Memorandum

SUBJECT: LUC-2019-380 – 5 FERNTREE DRIVE – APPLICATION TO REMOVE A SCHEDULED TREE

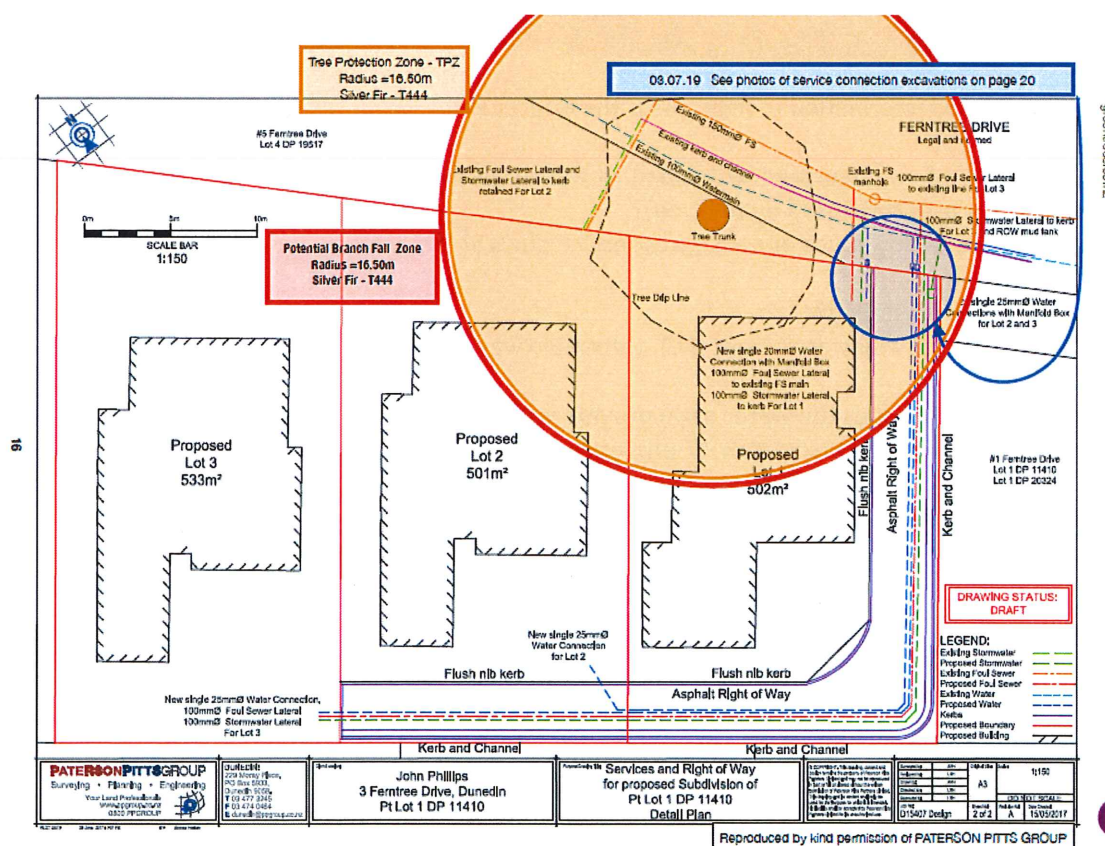
Is Council aware of any issues with/damage to this watermain or services pipes shown in the survey plan below (that may be caused by the tree)?

We are not aware of any issues or damage to service pipes in this area.
